Addendum #4

July 13, 2015

ELECTRICAL
 PROJECT TITLE
 MIXED USE DEVELOPMENT
 721 MONAGHAN ROAD
 PETERBOROUGH, ONTARIO

Request for Tender
Addition and Alterations
for “The FireHouse Complex”
721 Monaghan Road, Peterborough

DATE	PROJECT NUMBER	DRAWING NUMBER
FEB. 2015	4-4576	E-2 OF 6

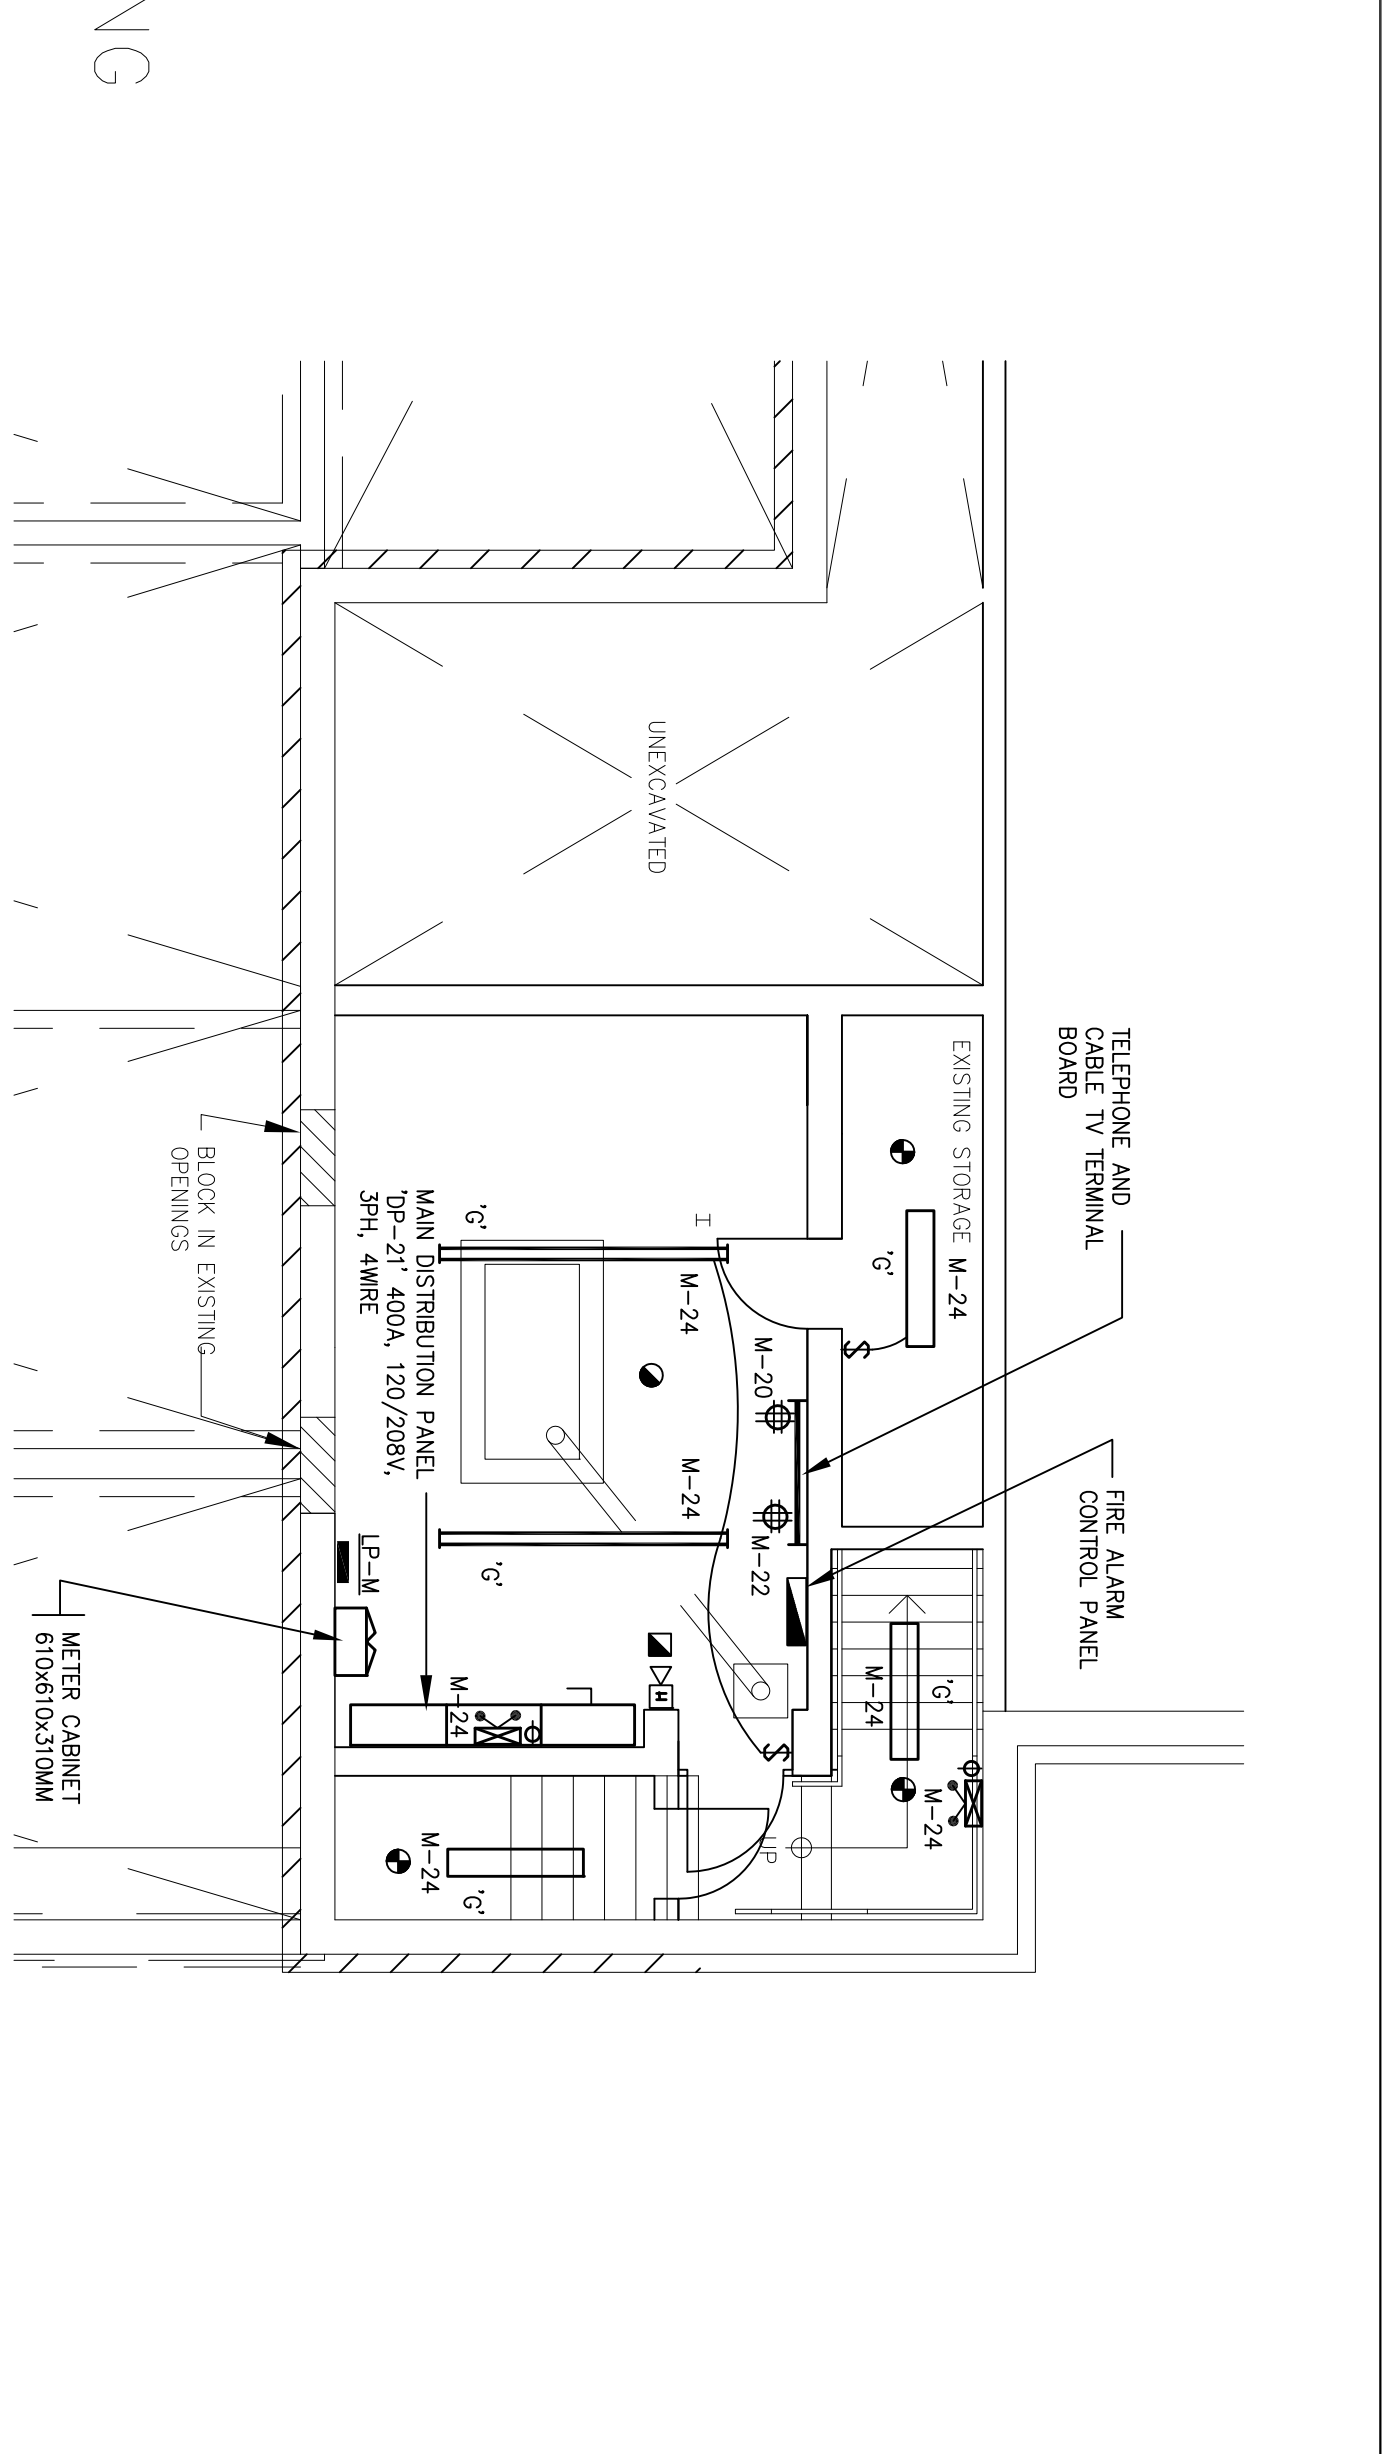
1. See attached drawings E-2 (R1), E-3 (R1) and E-5 (R1), attached.
2. Silencing switches and isolators for the Suite mini horns have been deleted on drawings E-2 and E-3.
3. Two Type "L" fixtures have been added in the Corridor on drawing E-2.
4. One Type "H" fixture has been added in the Corridor on drawing E-3.
5. Suite layouts for Suites 205 and 206 have been updated on drawing E-3
6. The Electrical Legend has been updated on drawing E-5.
7. A note for "Smart Metering" has been added on drawing E-5.
